**Comanche Peak Nuclear Power Plant, Units 3 & 4
COL Application**

**Part 2, FSAR
Update Tracking Report**

Revision 4

Chapter 2 Tracking Report Revision List

Figure 2.4.3-202 Watershed Sub-basins

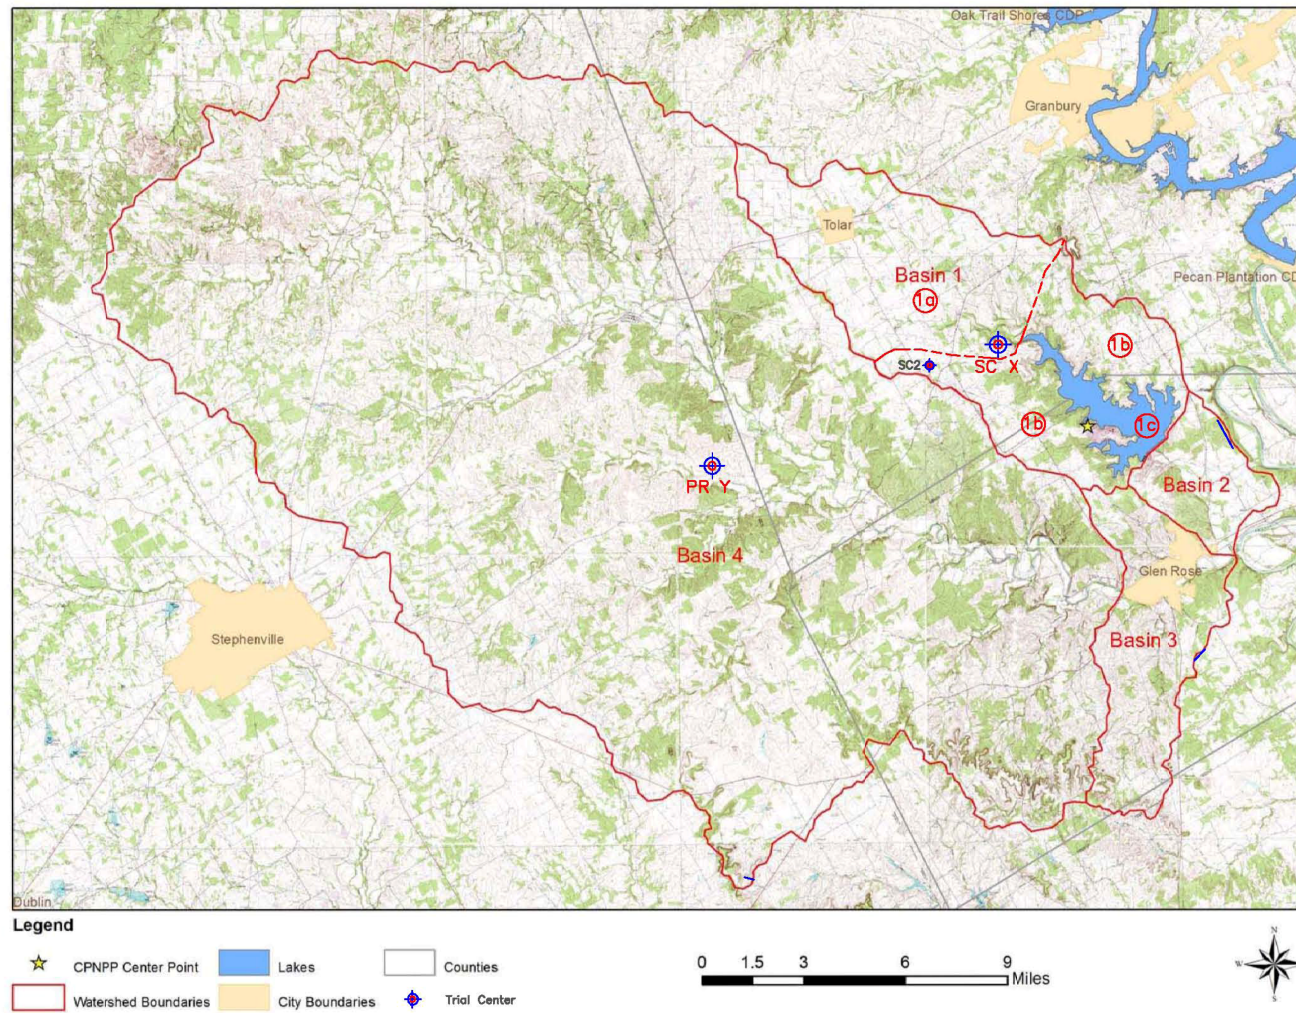
For the Squaw Creek watershed, the critical storm center was found to be near the watershed centroid, identified as point SC X in [Figure 2.4.3-202](#). A storm center at SC2 results in the maximum PMP for the Squaw Creek watershed. The storm center SC X results in a higher runoff and hence SC X is considered to be the critical storm center for the Squaw Creek watershed. The critical storm area was found to be 700 sq mi, corresponding to isohyet H in [Figure 2.4.3-201](#). The critical storm orientation was found to be ~~160~~145 degrees.

The runoff and stream course models are based on an existing study for the SCR. The watershed and subbasins are shown in [Figure 2.4.3-202](#). Basin 1 was further subdivided into three subbasins – 1a, 1b, and 1c. Basin 1a represents the drainage area above the SCR, Basin 1b represents the contributing area adjacent to the SCR, and Basin 1c represents the SCR. Drainage areas for each subbasin are provided in [Table 2.4.3-207](#).

Figure 2.4.3-209 Coincident Wind Wave Activity Fetch Length

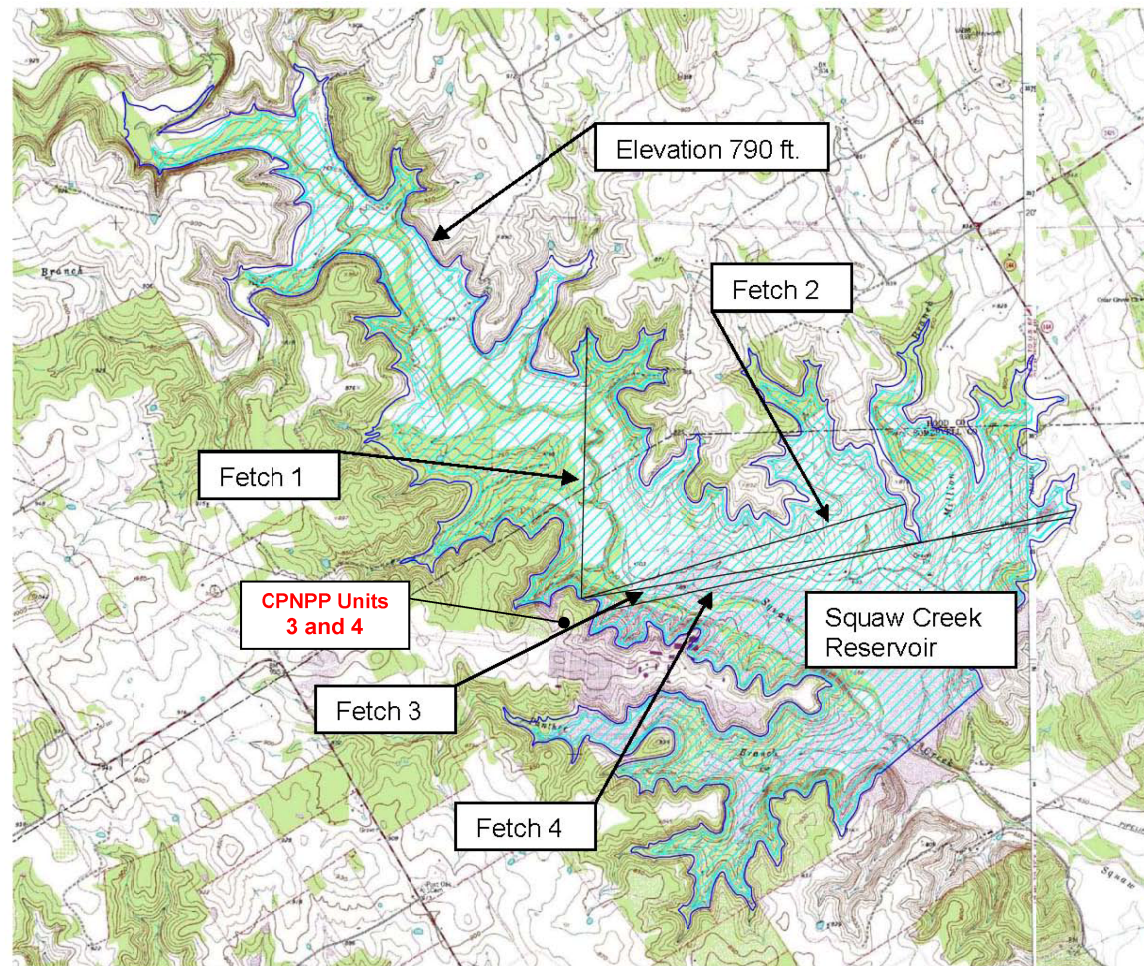
Fetch length was estimated based on USGS Quadrangles. The critical fetch length was found to be ~~2.66~~2.67 mi originating from the east for Fetch 3 as shown in **Figure 2.4.3-209**. CPNPP is protected from wind wave activity from the west and south by the local topography. Wave height, setup, and runup are estimated using USACE "Coastal Engineering Manual, EM 1110-2-1100" guidance (**Reference 2.4-235**).
